IRIS FABRICS LIMITED (Extension Building)

1. Printing and Dying Building(G+M+5) (reinforced concrete structure)

Observations

Details of Combined footing

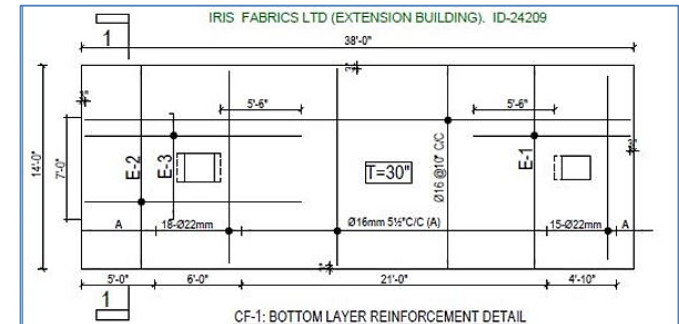
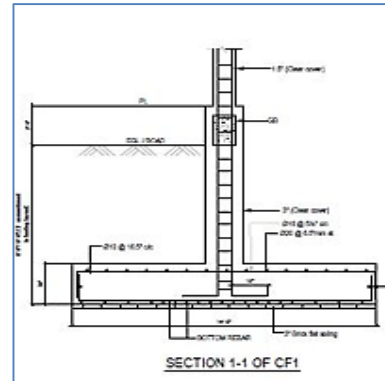
Cursory calculation indicates that footing (under the overhead water tank) appears to be stressed above normal design limits considering the live load provided in design report (4kPa) & equivalent concrete strength (26.22MPa). Also, considered the recommended allowable average soil bearing capacity 14.22 ton/m² (FoS- 3.0) at 2.5 m depth based on 8 bore logs data in geotechnical report and footing sizes in drawing. Factory engineer is required to review the adequacy of footings and comply with BNBC.

Storage

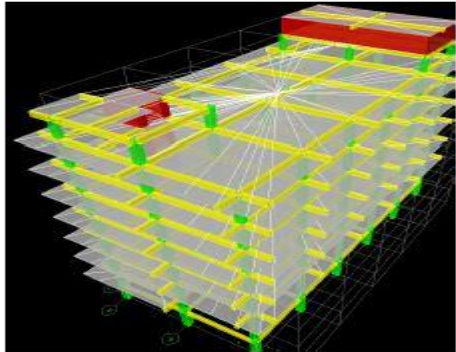
Columns appears to be stressed above normal design limits considering the considering the live load as per BNBC (minimum storage live load 6kPa) and equivalent concrete strength (26.22MPa). Factory engineer is required to review the adequacy of column and comply with BNBC.

Pile details

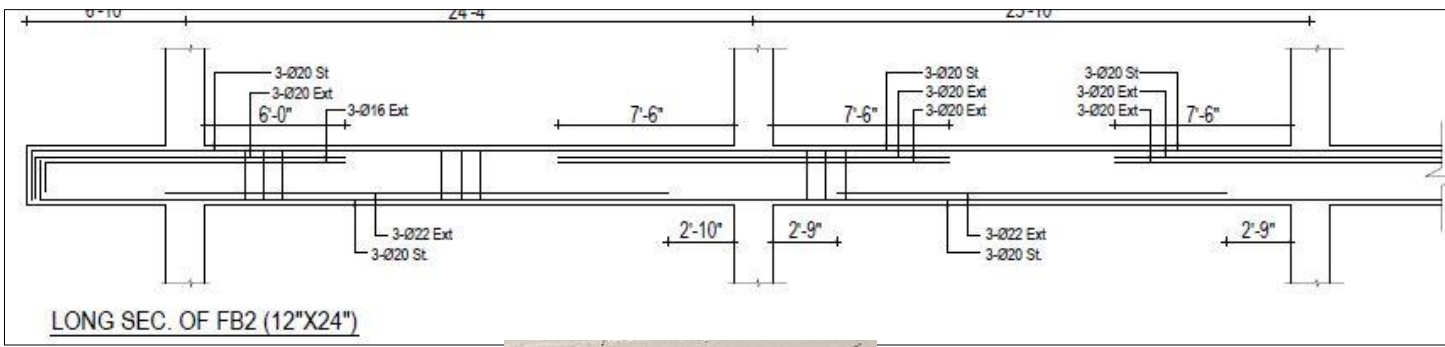
A Design Report was provided for Printing and Dyeing Building. Information of pile was provided in the drawings. But detail calculation was not found in the design report regarding the pile capacity. Moreover, serviceability checks were not provided in the design report.

Inconsistencies in as-built drawing

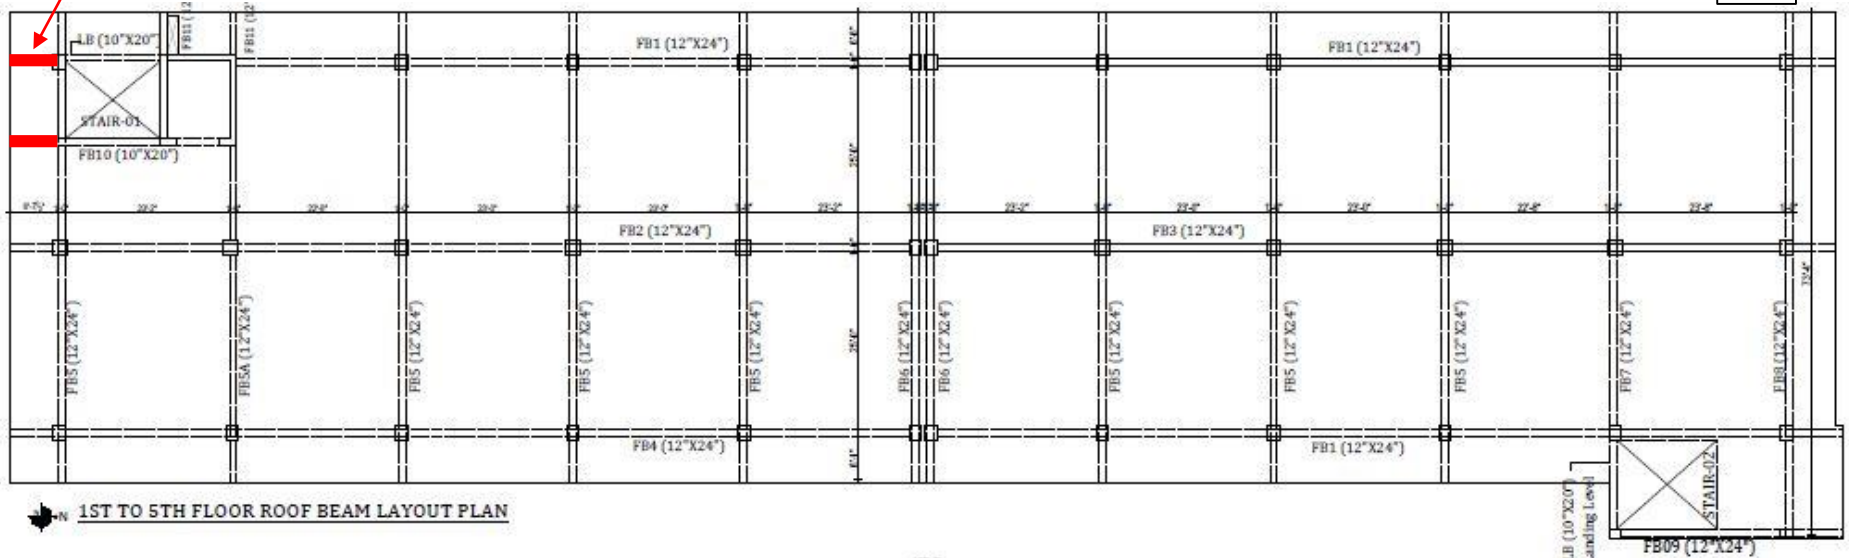
Typical beam size was found 12" X 22" instead of 12" X 24". Also cantilever beam was found all side of the building which was not match with the provided structural drawing.

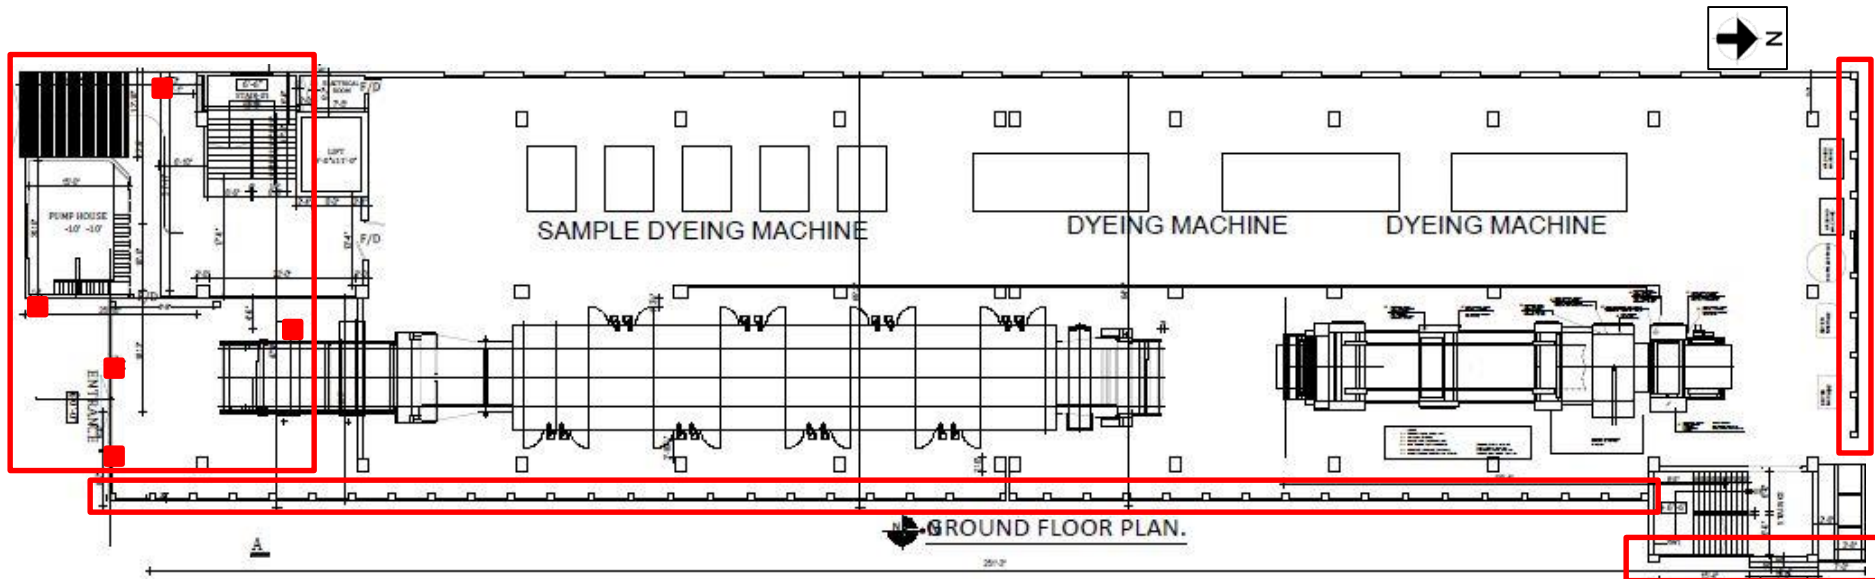
In the architectural drawing, few RC columns in ground floor was shown but no structural information was found for that RC columns and foundation system. Also, pump room was structurally connected with the mezzanine floor slab, which was not shown in drawing.

Landing Joist

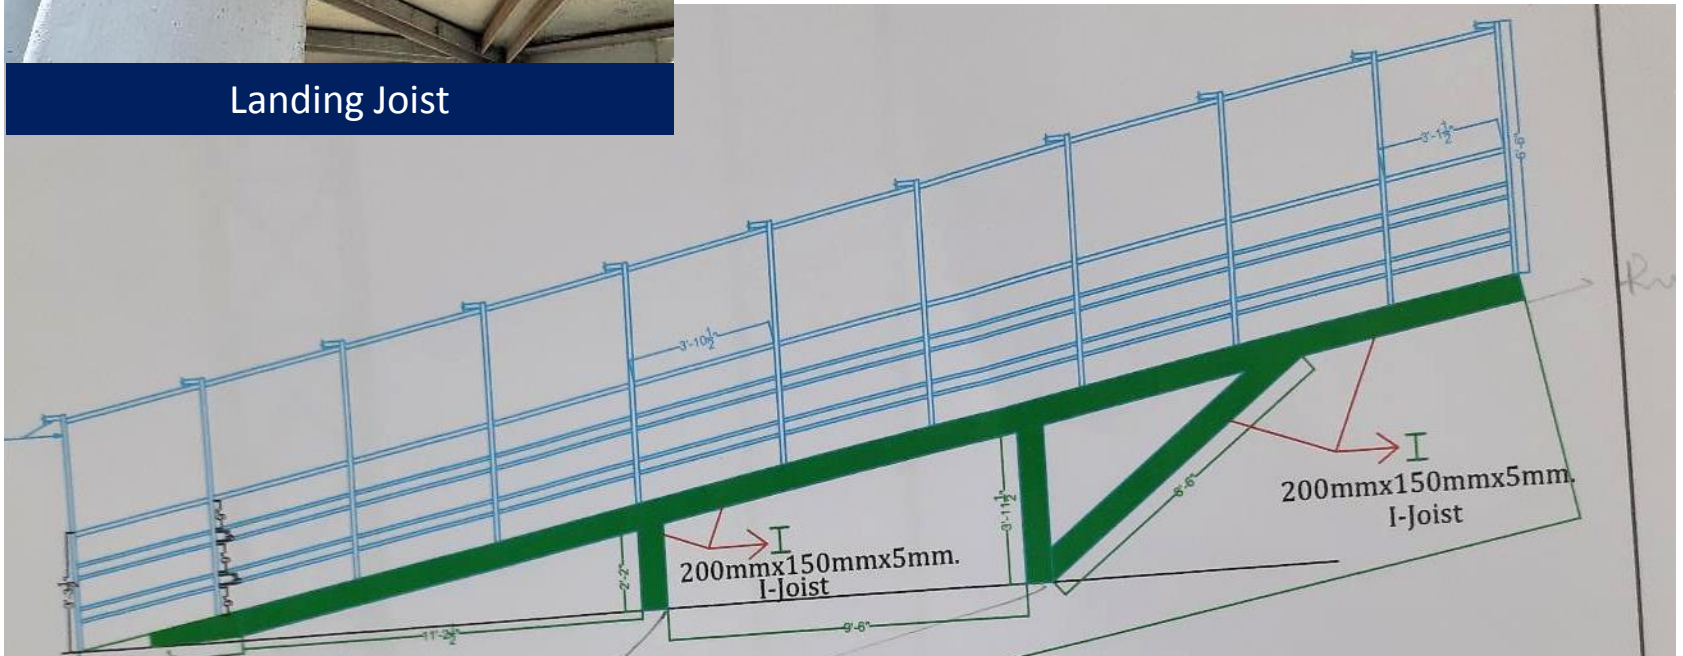
The flange width of steel joist was found 130 mm instead of 150 mm. Also, no connection details have been found in the drawings.

Column Layout

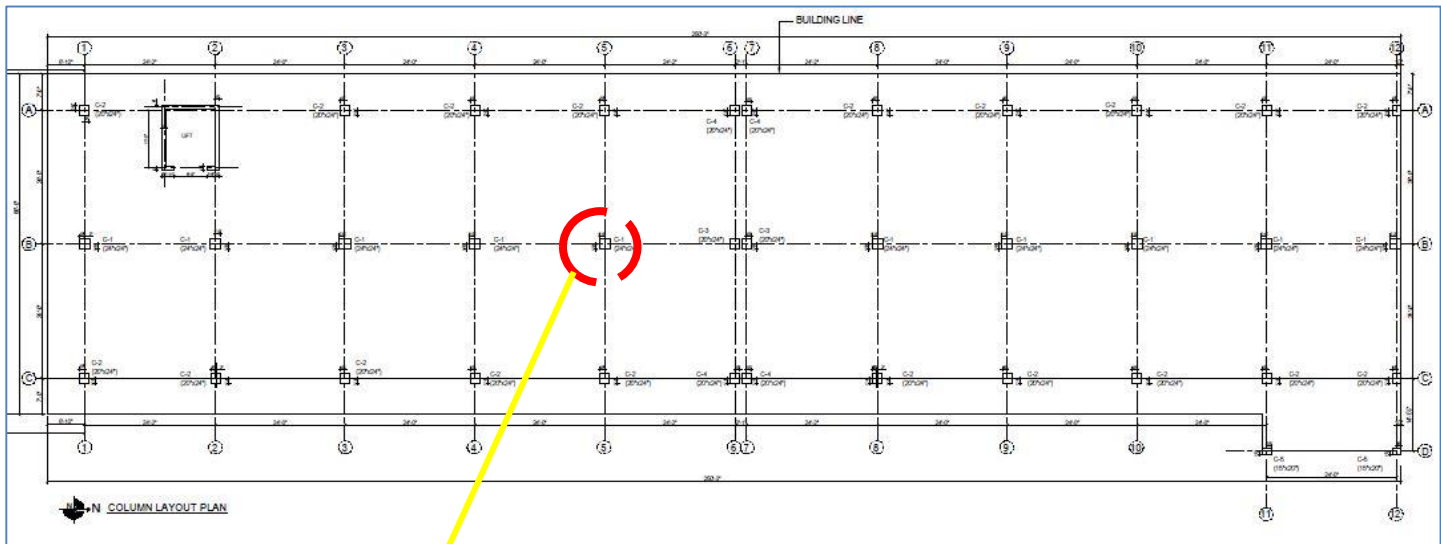
Marked column was tested for aggregate type and stone aggregate was found.
